Access Compliance Report Public Rights-of-Way (Pedestrian Signals)

Main Street: PROSPECT_ST Cross Street: FAIRHAVEN_AVE Location: NE

ADA ID: SGAT211022104322 Signal Type: One Push Button-Non APS Overall Compliance: No Severity Scores: BTN 1: 35 BTN 2: N/A No BTN: N/A

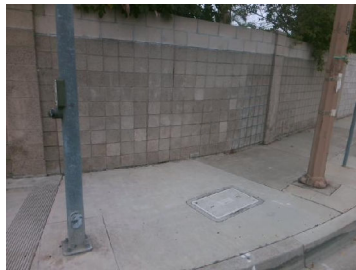
Possible Solutions: Replace Signal Push Button With APS Button. Remove and Replace Clear Space.

OC Std/PROW: R404.2, R404.3, MUTCD 4e.08
